**STAFF RECOMMENDATION**

**216 Fairfax Avenue**

**September 17, 2014**

**Application:** New construction – addition and outbuilding  
**District:** Hillsboro-West End Neighborhood Conservation Zoning Overlay  
**Council District:** 18  
**Map and Parcel Number:** 10406009000  
**Applicant:** Kevin Mitchell, Designer  
**Project Lead:** Sean Alexander, sean.alexander@nashville.gov

**5** ELEVATION - new garage facing back of house  
 SCALE: 1/4" = 1'-0"

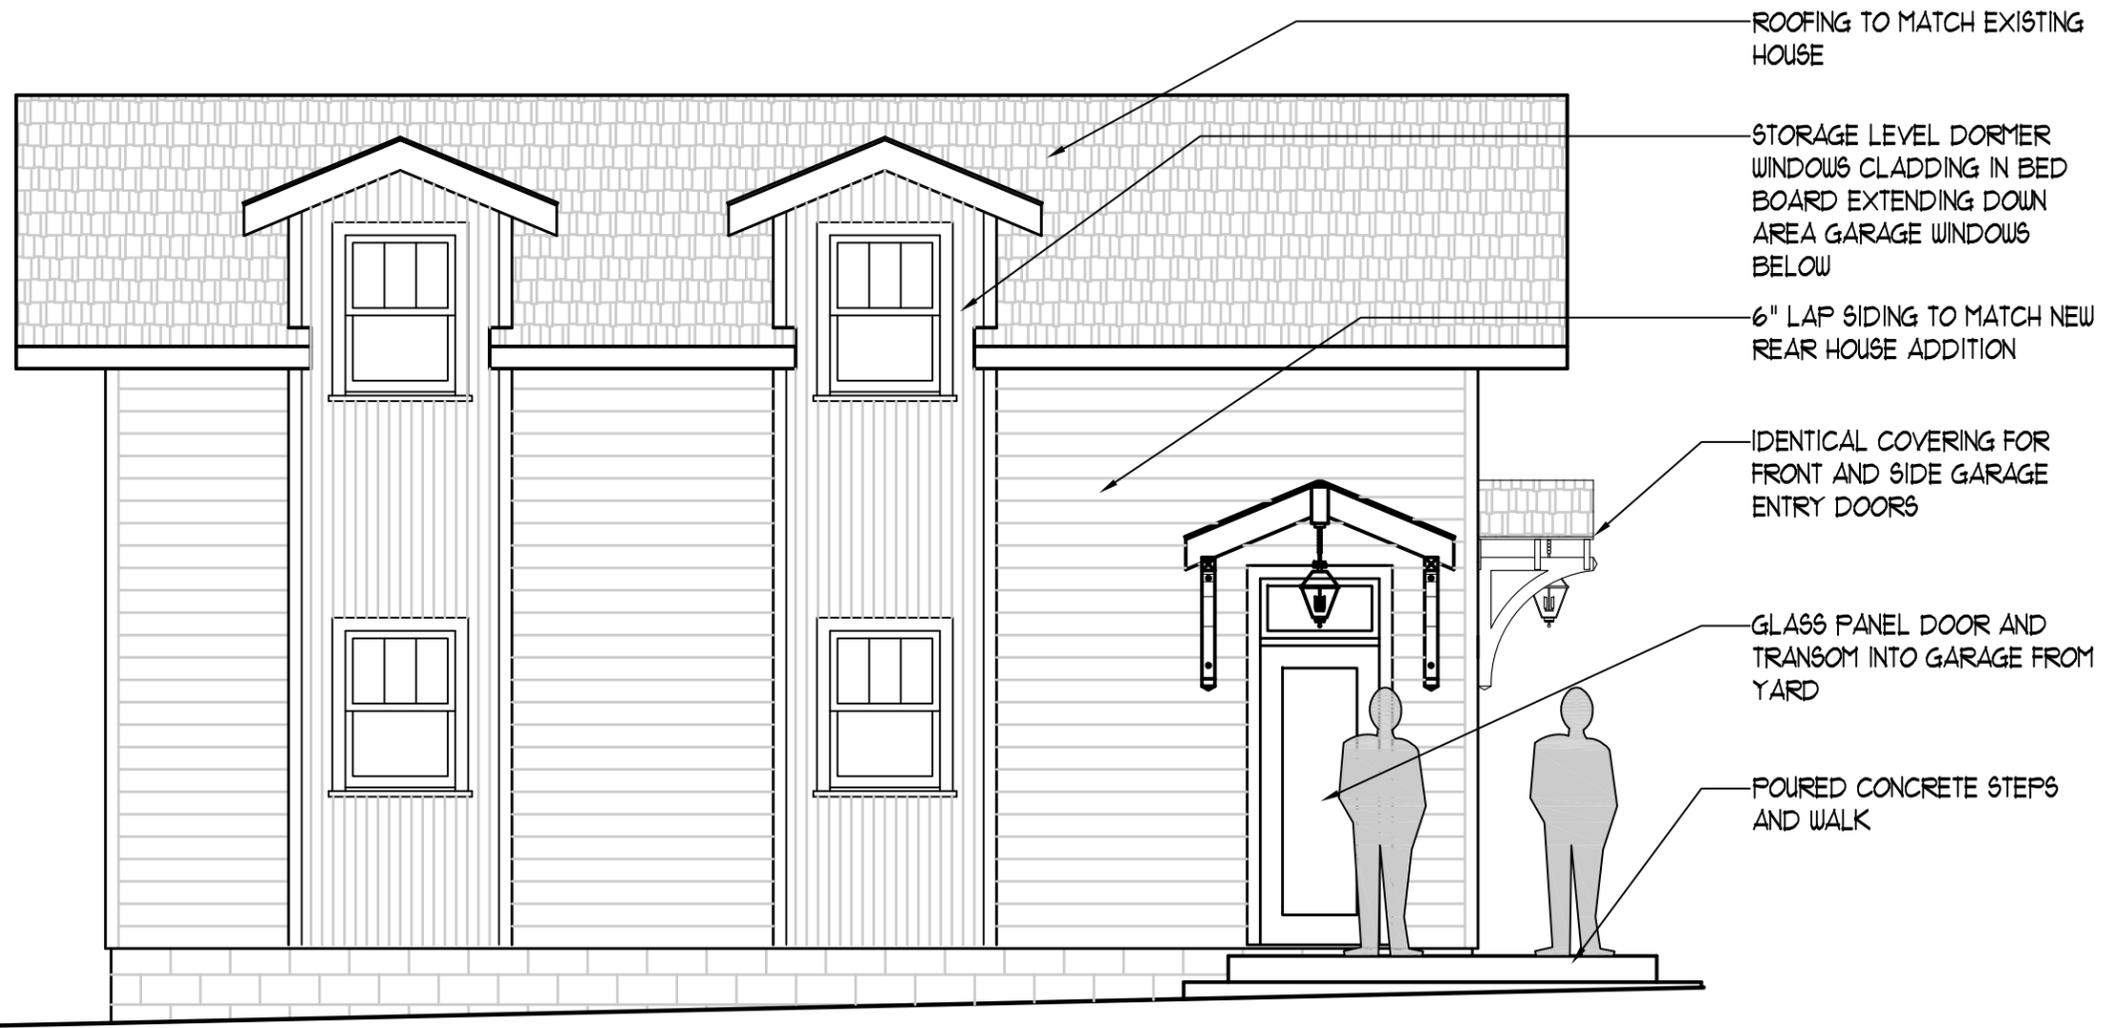
The new outbuilding will have two floors, with a two-car garage on the first story and a bonus/storage area above. The roof peak will be eighteen feet, nine inches (18'-9") above the lower floor level. Because the lot slopes up toward the rear, the peak of the garage will be three feet, two inches (3'-2") higher than the peak of the house. However, the height of the roof measured from the finished floor level will match the house. In order to achieve a truly subordinate outbuilding, it must be subordinate in all ways: ridge

height, eave height, footprint and square footage. The eave height of the garage will be twelve feet, nine inches (12'-9") above the lower floor level. This is nearly three feet (3') greater than the proportional eave height on the house. Staff finds that the ridge and wall heights are not subordinate because they are equal to or greater than the comparable proportions of the house. In the past, the Commission has placed an emphasis on appropriate eave height since it is such a key factor in assuring that the massing of an outbuilding is perceived to be subordinate to the principal building. With the eaves of the outbuilding lowered to match the eave height of the house, and the ridge height lowered, staff finds that the height and scale of the project meet would meet section II.B.1.a and b. of the design guidelines.

The materials of the outbuilding will match those of the new addition: asphalt-single roof, cement-fiber siding, and a concrete foundation. The trim will be wood. The windows and doors will be wood, and staff asks to approve the final window and door selections prior to purchase and installation. On the front elevation of the building there will be vertically-oriented bead-board panels around the windows, extending the full height of the building. Bead-board is not a typical siding material. Although board and batten or vertical flush-siding is an appropriate material for an outbuilding, staff finds that the attenuated scale of bead-board in this application exaggerates the height of the wall, which is already taller than the walls of the house. With a condition that the a more appropriate siding material is used instead of bead-board accent panels, staff finds that the known materials of the proposal meets section II.B.1.d

The roof of the outbuilding will be a side-facing gable with a 5:12 pitch, matching the pitch of the house's roof. Both the front and rear elevations will have a pair of gabled wall-dormers. Wall dormers are not a typical historic feature but have been allowed on minimally visible garages; however, in this case, they only help to accentuate the fact that the ridge and eave heights are too tall. The height of the eaves above the finished floor level would be nearly three feet (3') taller than the same proportion on the house. Staff recommends that the dormers be roof dormers rather than wall dormers to meet section II.B.1.e. The bead-board could be covered under materials but what should be covered in this section is the roof-wall dormers vs. roof dormers.

- The selections for windows and doors are approved by Staff prior to installation; and
- The eave ridge and eave height of the garage is lowered to be subordinate to the house; and
- The dormers are of a more compatible form (roof dormers within the plane of the roof instead of wall dormers, and/or having a more appropriate siding material used instead of bead-board on the outbuilding).
